Access Compliance Report Public Rights-of-Way (Curb Ramps)

Main Street: YELLOWTAIL_DR Cross Street: DRUID_LN Location: SW

ADA ID: RPRK211207113429 Ramp Type: Type 4 - Parallel Initial Pass/Fail: Fail Overall Compliance: No Severity Score: 15

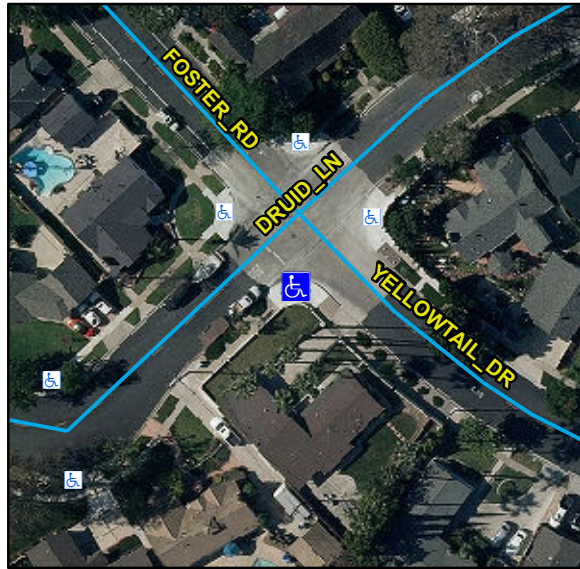
R304.5.3, STD 1115

Remove & Replace Curb Ramp With Two New Directional Ramps or Equivalent.
